ASML

IEUVI Mask Technical Working Group

Proposed changes P37/P38/P40 SEMI standards

Thursday, Feb 28, 2008

Figure 4

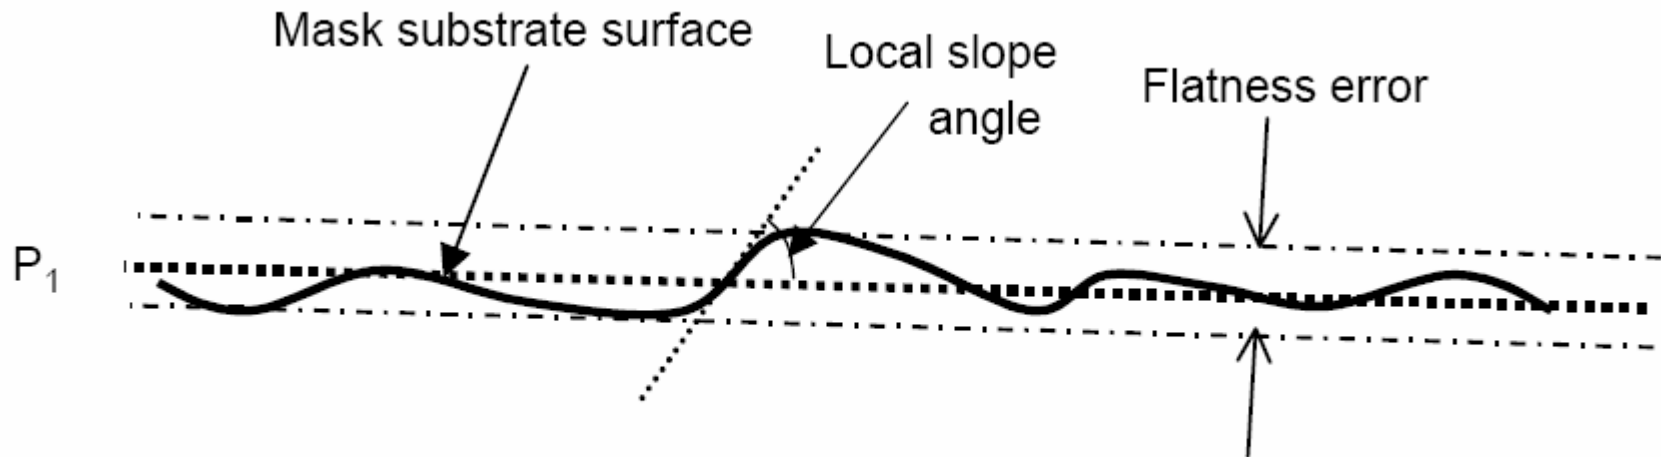
Definition of flatness should have the Bow removed – otherwise it will be impossible to make reticles

ASML Proposal:

P1 is the plane after bow removal that minimizes the maximum deviation of the surface

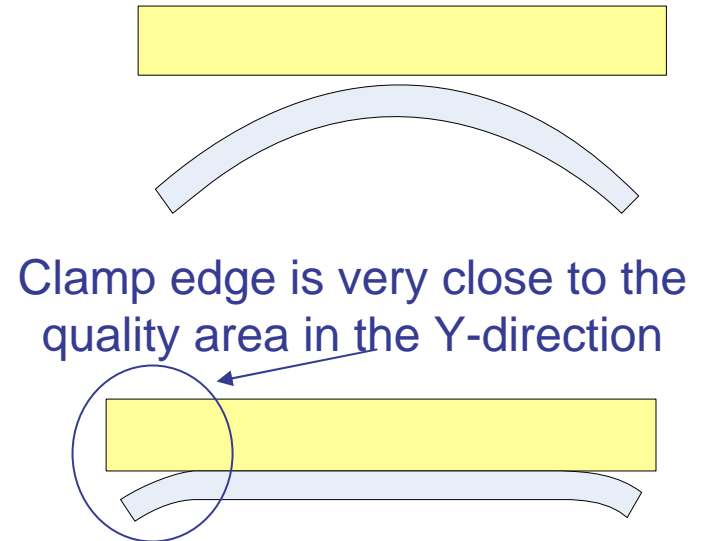
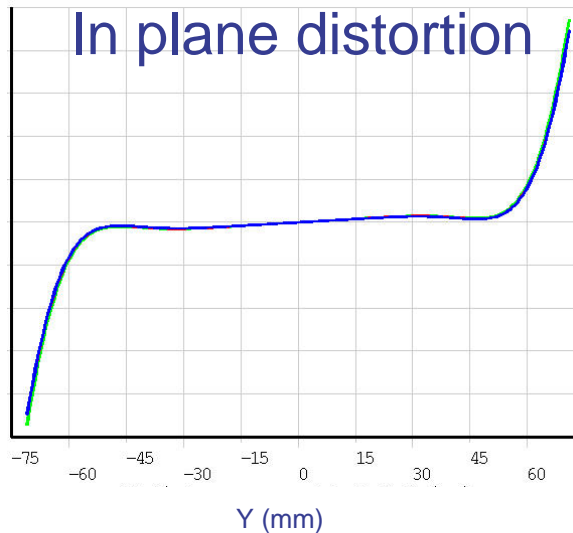
When clamped, reticle bow adds primarily in plane distortion (IPD)

- Reticle bow does not lead to a fully linear distortion due to edge effects of the clamp
- Even with clamp optimization, bow less than $1\mu\text{m}$ is needed to meet the targeted overlay

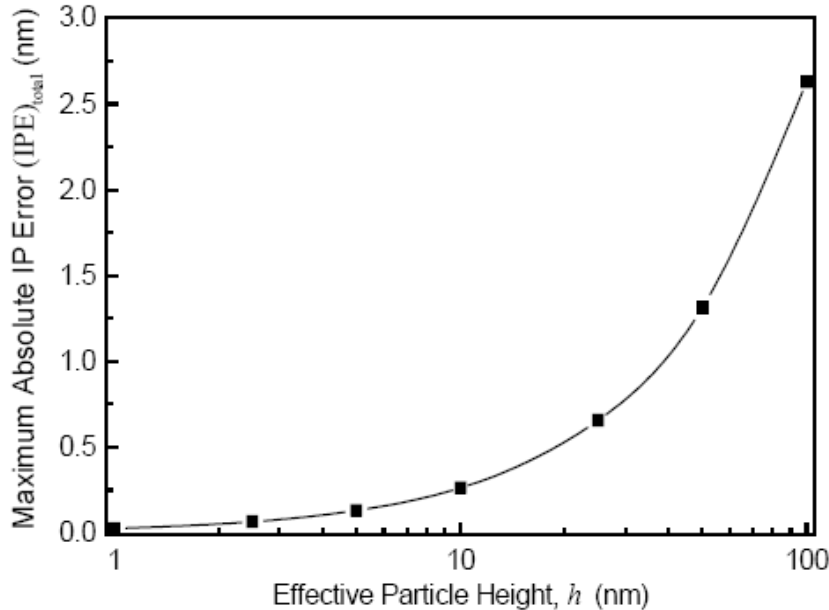
Effective height of reticle backside particle may need to be below 40nm

Once coated, particles might not be deformable

Expected reticle operating temperature range for High T-put HVM

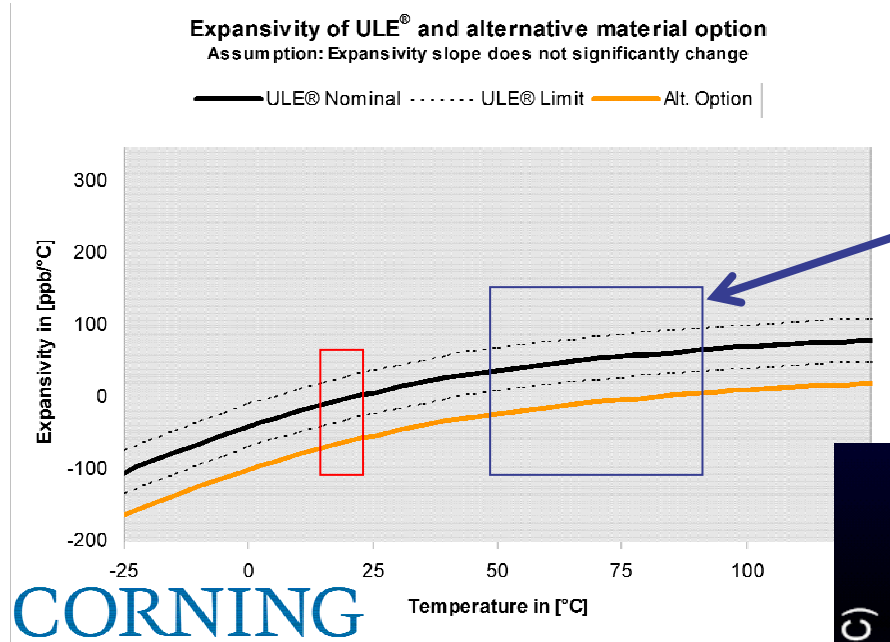
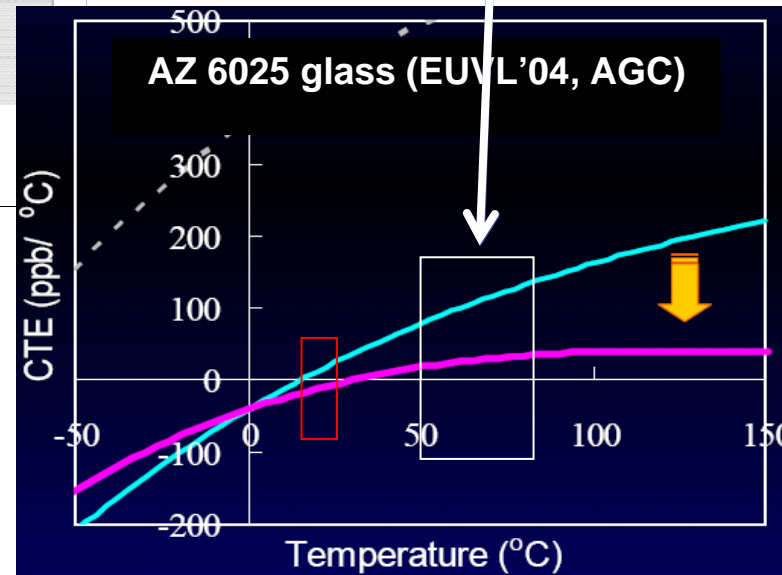
CTE spec does not match the operating temperature range for high-volume tools

- For High T-put tools the reticle operating temperature will be substantially higher than 25°
 - Current estimates with 67% reticle reflection, heat conductivity of 1.5 W/m·K, reticle thickness 6.35 mm, show operating temperatures of 50...80°C
- At operating temperatures 50...80°C, CTE of current LTEM materials will largely exceed allowed values
- Thermal expansion specification needs to be reviewed

LTEM materials can be tailored for a specific cross over temperature

Task force should review the CTE issue and potential solutions

Table 2 Specifications for Chamfered and Rounded Edge Dimensions

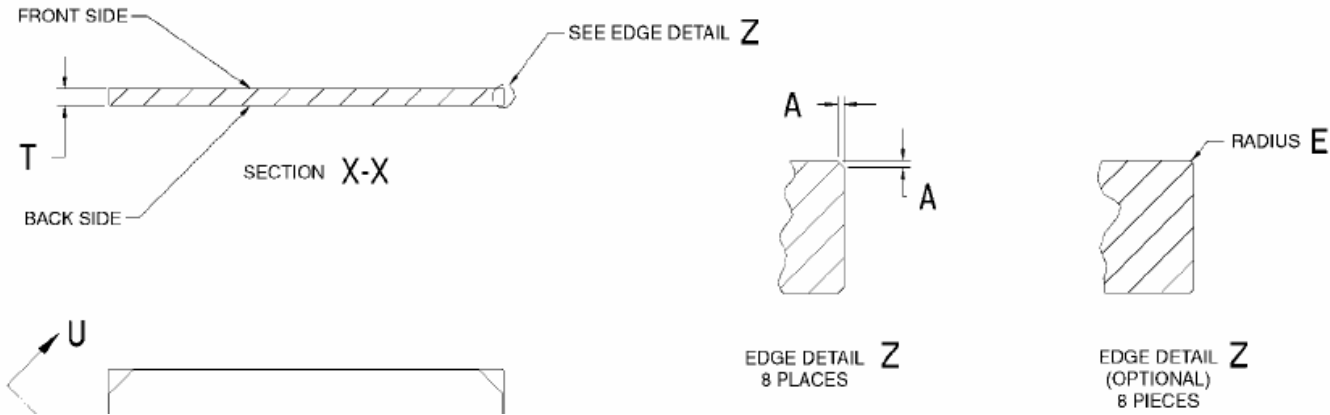
Chamfer may need to be opened up to make reticle less prone to edge chipping

Table 4 Median Wavelength And Bandwidth Of EUV Reflectivity Of Multilayer Stack

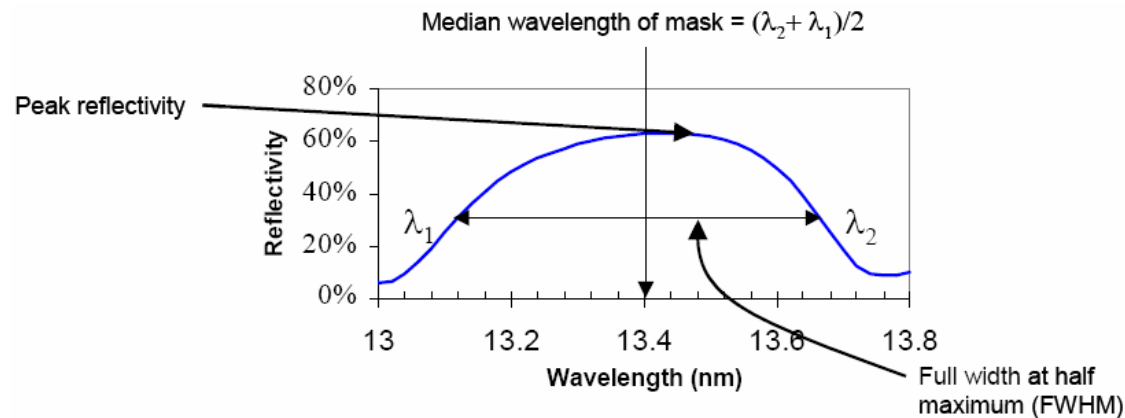
User should define the wavelength spectrum centroid

Mean FWHM of reflectivity Vs wavelength	> 0.50 nm
Center wavelength definition	Agreed upon between user and supplier (Either median or peak)
Mean reflected center wavelength	Agreed upon between user and supplier

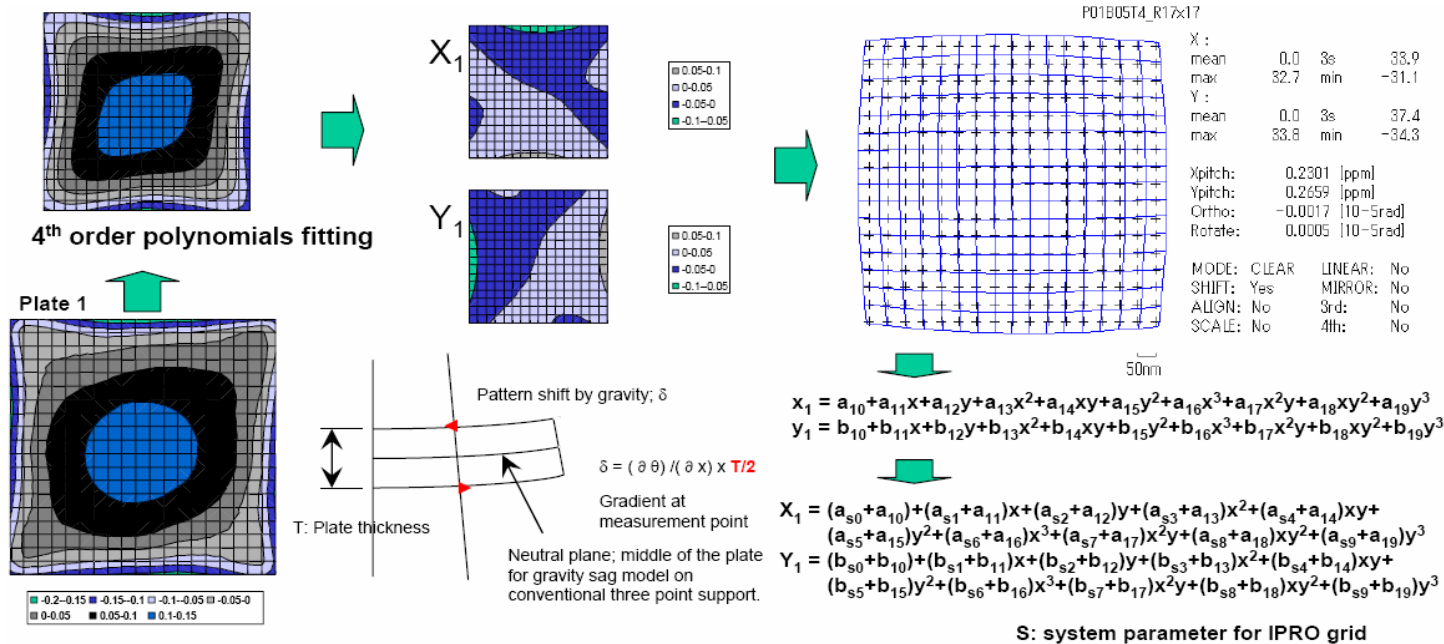
ITRS roadmap and SEMI Standards values for reticles and clamps are necessary to meet the 5.7nm 32nm node overlay target

Without tool dedication, the target overlay cannot be met
